World Forum for Harmonization of Vehicle Regulations

Proposal for Supplement 8 to the 01 series of amendments to Regulation No. 123 (Adaptive front-lighting systems (AFS))

Submitted by the Working Party on Lighting and Light-Signalling*

Supplement 8 to the 01 series of amendments to Regulation No. 123 (Adaptive front-lighting systems (AFS))

"Figure 1

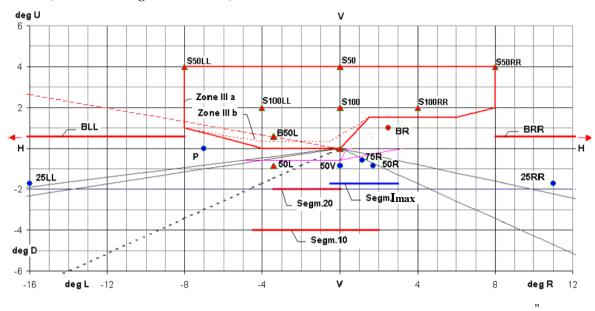
Annex 3,

Figure 1, amend to read:

Angular positions of passing beam photometric requirements (indicated for right-hand traffic)
